Service Bulletin

NO:HIFI2-01-009

SUBJECT: "PROTECTED" Is Shown On The Display

MODEL (S): MZ-R90, MZ-R91

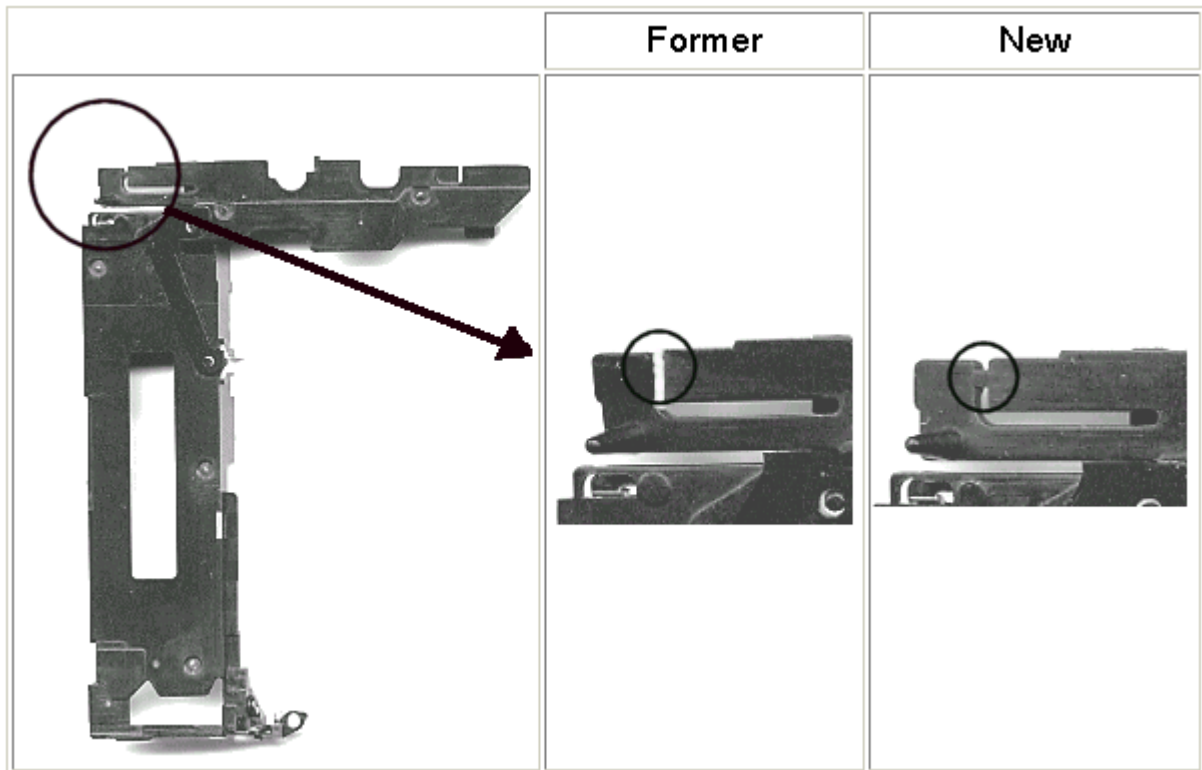
Symptom: "PROTECTED" is shown on the display and the recording and the editing is unable to do.

Solution: Replace the Battery Case Assy with the improved one.

Description	Former	New
CASE ASSY, BATTERY	X-4952-043-1	X-4952-043-5
